Road Safety Audit
Stage 1
for
PROPOSED MIXED USE DEVELOPMENT
AT
NEWTOWN, DROGHEDA, CO LOUTH

Report produced by: Road Safety Matters

Reference: RSM/MOB/080719/NEWTOWN RSA1

Client	Waterman Moylan Consulting Engineers
Project Title	Proposed Mixed use Development, Newton, Drogheda, Co Louth
Document Title	Stage 1 Road Safety Audit
Document Ref.	RSM/MOB/080719/NEWTOWN RSA1
Status	FINAL

Figure 51

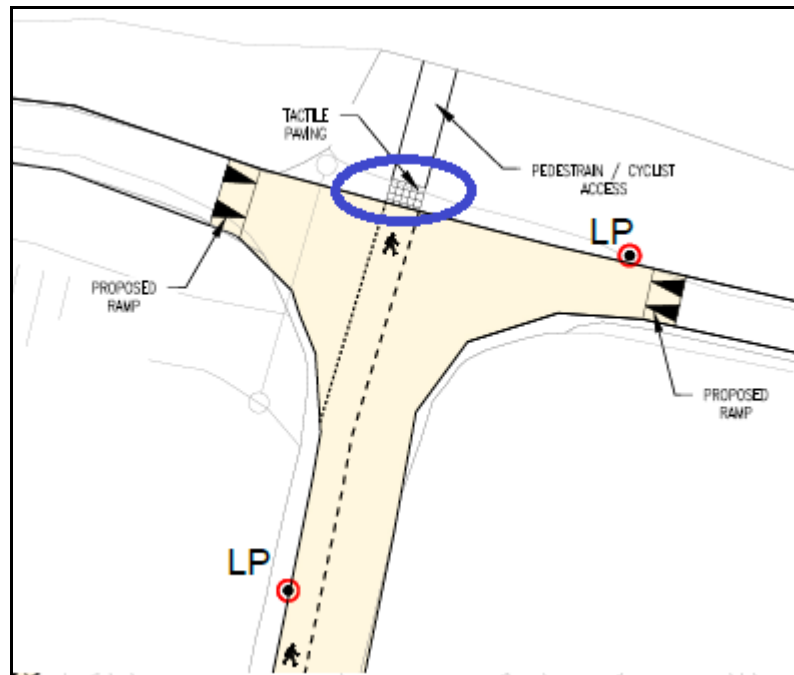
- Tactile paving has been provided at the southern link to the site at the intersection with McGrath's Lane, as shown in figure 51, which leads visually and mobility impaired pedestrians directly into the centre of the carriageway, on a shared surface where rights of way and priority are unclear, and where the risk of conflict with moving vehicles is higher. This will occur at a location where intervisibility is compromised by the bridge crest, and abutment walls, as shown in figure 52.
- There is no provision for tactile paving at the top and bottom of steps within the site to alert visually impaired pedestrians to the presence of the hazards.

Pedestrian activity, desire lines and demands should be considered both within the site, at tie-in points, and on routes used to access the site, with detailed design layout to be finalised taking into account all issues raised above. Details of all kerb heights throughout the site to be clarified at detailed design stage, with a maximum kerb upstand of 6mm to be installed on all desire lines to cross the carriageway across the path of moving vehicles, and dropped kerbs ideally flush with the adjacent road surface. Footways should be continuous, clear and unobstructed at all times, with a minimum continuous width of 2m to be provided in an urban zone, and a minimum controlled crossing width of 2.4m to be provided on the R150 subject to a review of pedestrian and vehicular volumes, to be increased to 4m if the crossing is to be shared with cyclists. All street furniture should be located to the rear of the footways where possible in a location which does not compromise the footway width to less than the absolute minimum desirable width of 1.2m on isolated sections. Overhanging trees should be cut back to minimise slip hazards arising from fallen leaves and to improve lighting conditions and VRU conspicuity. All chamber covers and gullies should be flush with the surrounding pavement and ideally located outside pedestrian and cyclist desire lines. Intervisibility at all crossing points within the site and surrounding the site should be clear and unobstructed at all times in accordance with traffic speeds.

Figure 60

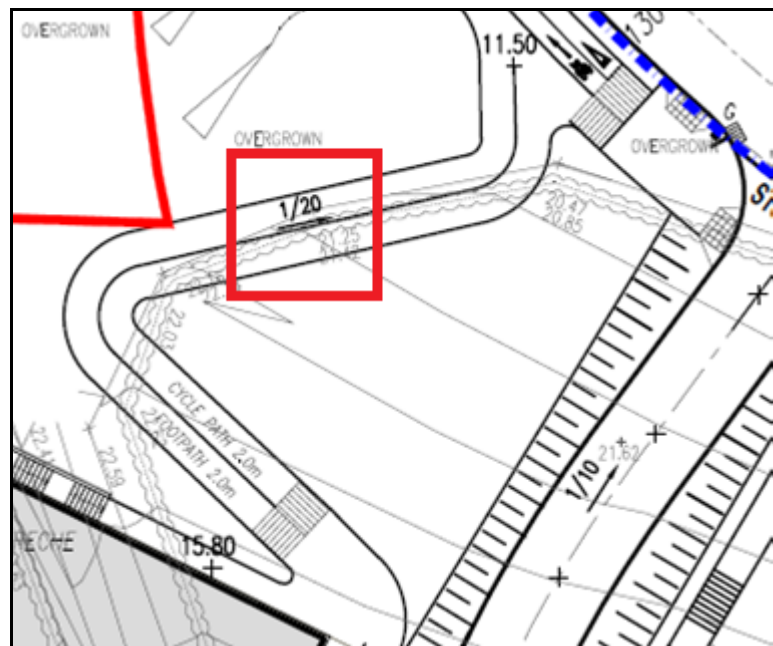
- Gradients are exceeding 3% on new dedicated cycling facilities, as shown in figure 60, which is a departure from standard, with a gradient of 8% on the new LIHAF and gradients exceeding 10% on links into basement carparking.

Likely cyclist volumes and desire lines should be considered in enhancing accessibility to and from and within the site, in line with the aspirations of DMURS in an urban environment. All cycling facilities should be sufficiently wide to accommodate safe two way cycling where possible, and where this is not possible, safe provision should be made for cyclists approaching from the opposite direction. Connectivity should also be provided to the surrounding network, with discontinuous facilities to be avoided, and with clear signage to be provided at the start and end of all facilities, with provision for suitable dropped kerbs where necessary to facilitate transfer from on to off road facilities, and vice versa.

2.3.2 Problem - Cyclist Provision	Yes	<p>Potential cyclist activity has been reviewed as part of the Mobility Management Plan Report included as part of this SHD Application. Cyclists will transition to be on-road where there are no off-road cycle-tracks, particularly at the interface to existing roads. The gradients on the LIHAF Road have been agreed with Louth County Council as part of the detailed design of same. Given the topography of the site it is not feasible to limit cycle path gradients to 3%. The southern</p>		Yes ⁸

Figure 61

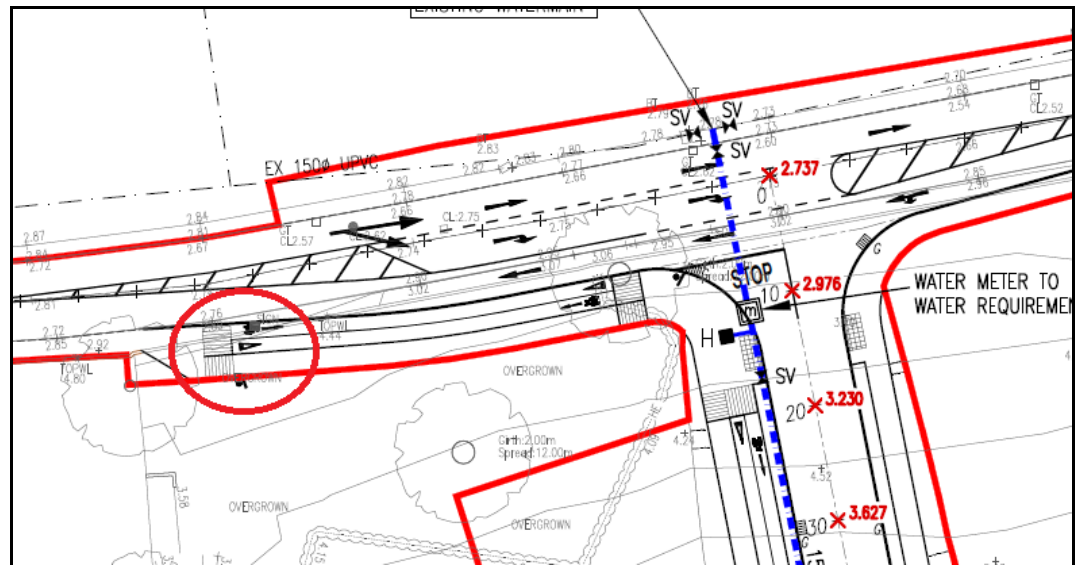
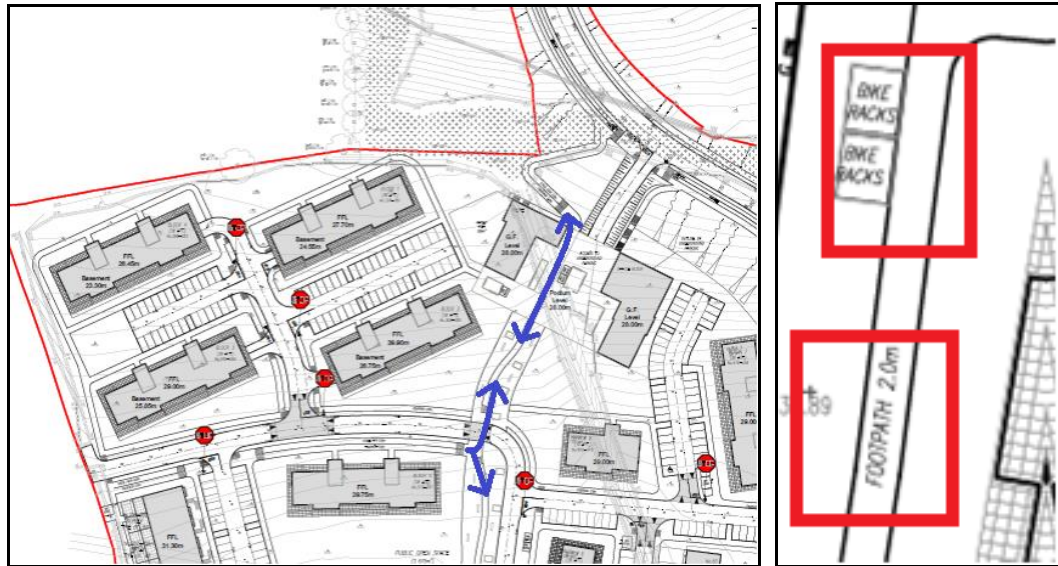
- The shared cycleway/footway at the south of the site (McGrath's Lane) is too narrow for shared use, and the continuity of the route for cyclists on Railway Terrace and on the R132 is unclear. Cyclists will be more vulnerable at these locations.
- Continuity for cyclists is unclear elsewhere throughout the site, as highlighted in figure 62. Bike racks have also been provided at a number of locations adjacent to footways throughout the site, with an example shown in figure 63, where there is no clear provision for dropped kerbs to facilitate transfer from on to off road facilities, and where there is insufficient space provided on the footways for safe shared use.

link to McGraths Lane is a continuation of the shared pedestrian / cyclist corridor which consists of a 2m cyclepath and a wider paved surface for pedestrians. Surfacing details are indicated in the Landscaping Rationale. The internal site layout allows for cyclists to share the road space within the traffic calmed 30kph in accordance with DMURS. 2m wide off-road cycle-tracks have been provided at key links throughout the site to enhance connectivity. Drob kerbs and tactiles will be provided to facilitate access to bike shelters within the development. These will be shown on drawings at detailed design stage.

Figure 64

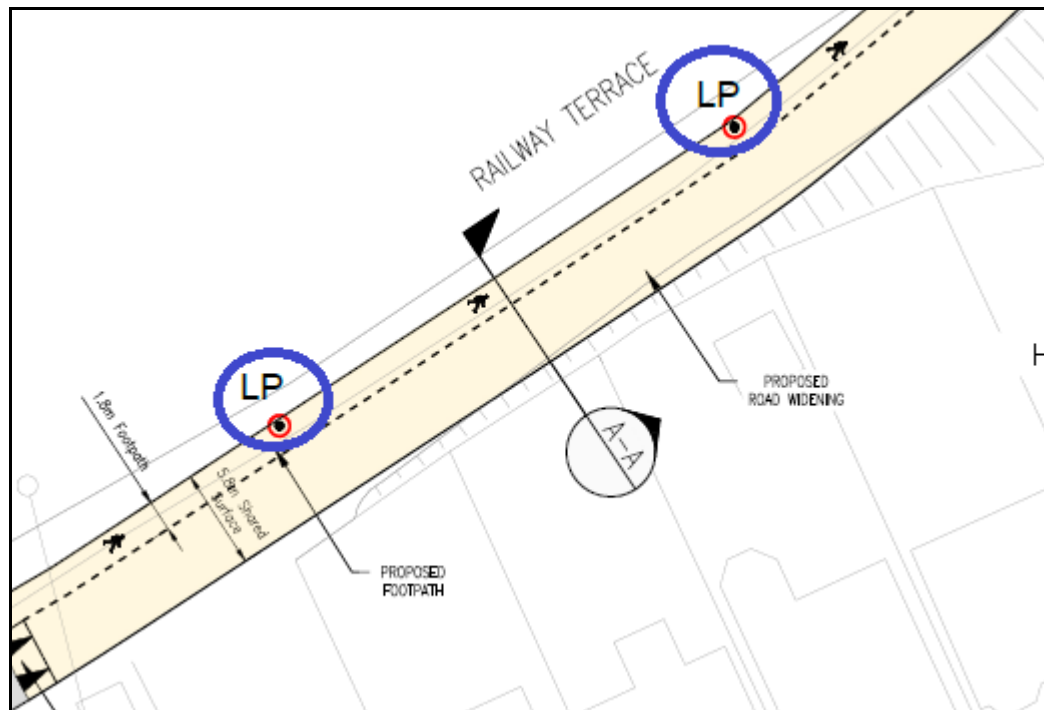
There were no proposed lighting details provided for the internal site. Inappropriate lighting can increase the risk of conflict during the hours of darkness, and inappropriately located lighting columns can obstruct footways and VRU movements, and can also present a hazard to errant vehicles if located too close to the carriageway edge. It was noted that a number of lighting columns will be provided along Railway Terrace within the proposed footway, as shown in figure

64, where they may obstruct the movement of VRUs and present a strike hazard to passing vehicles on a limited cross section. The columns on the railway bridge, highlighted in figure 65, may also, if struck, present a hazard on the railway line underneath.

Detailed design should include for new lighting proposals throughout the site and along the site frontage. All lighting columns should be placed to the rear of footway where possible in a position which does not obstruct the movement of VRUs, with all columns throughout the site to be located at a minimum offset of 450mm from the carriageway edge and away from areas where vehicles may wish to park, to avoid being struck by passing, turning and reversing vehicles. Lighting design should ensure there is no potential for dazzle or interference with lighting on the

adjacent public road network or railway line, and the column location on the railway overbridge should be reviewed to ensure all safety risks have been minimised.

2.4.1 Problem - Lighting	Yes	Lighting design will be carried out at detailed design stage and will comply with Local Authority Standards whilst noting the recommendations outlined in the RSA. The position of the lighting column on the railway over-bridge has been amended to mitigate associated risks.		Yes
